APPLICATION NO.	FILING DATE	FIRST NAMED INVENTOR	ATTORNEY DOCKET NO.	CONFIRMATION NO.
09/993,996	11/14/2001	Bernd Halbrock	65857-0037	8824

Office Action Summary

Claims 1, 15-23, 26 and 30-34 are rejected under 35 U.S.C. 102(b) as being anticipated by US patent 3600011, Alvis.

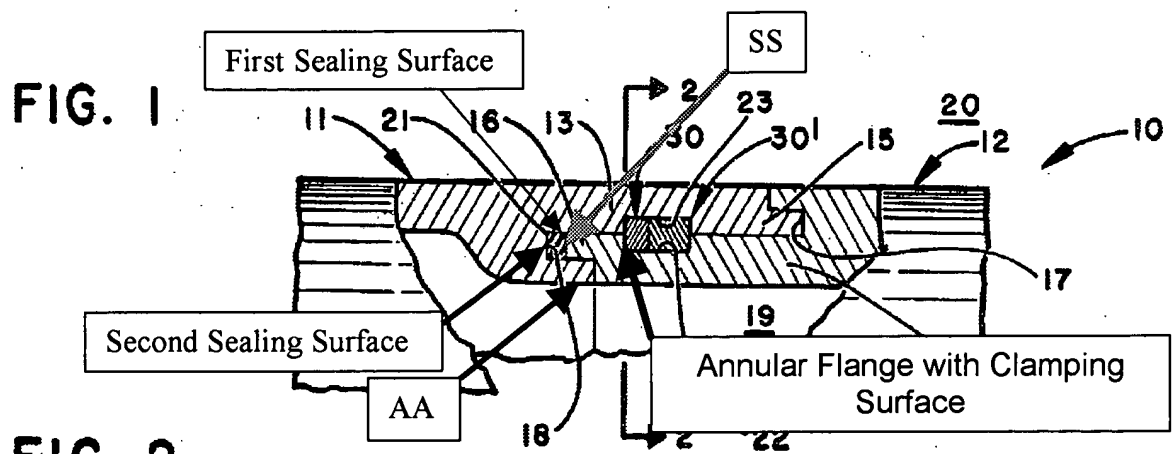
In regards to claim 1, Alvis discloses a quick-connect device for connecting fluid lines comprising:

a first connecting element (11) that includes an annular first support surface (AA), an inclined surface, and an annular receptacle space (18) with a first sealing surface and a second sealing surface,

an annular sealing element (21) that is arranged in the receptacle space and adapted to contact the first and second sealing surfaces,

a second connecting element (12) that includes a third sealing surface (SS) and an annular second support surface (16) adapted to contact the first annular support surface, and

a wedge-clamping device (30) that includes a clamping wedge adapted to contact the inclined surface of the first connecting element.

In regards to claim 22, in Figure 1 above, Alvis discloses the second connecting element including an annular flange with a clamping surface.

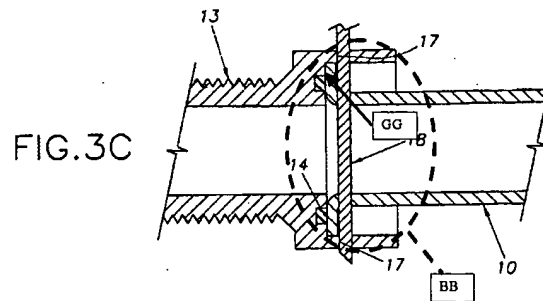
In regards to claim 24, Alvis discloses the claimed invention except for the clamping wedge being made from plastic. Olson et al illustrates a clamping wedge (10) being made of plastic. Further, plastic is a suitable material for use as a clamping wedge because of its low cost. It would have been obvious to one having ordinary skill in the art at the time the invention was made to fabricate the clamping wedge from plastic, since it has been held to be within the general skill of a worker in the art to select a known material on the basis of its suitability for the intended use as a matter of obvious design choice. *In re Leshin*, 125 USPQ 416.
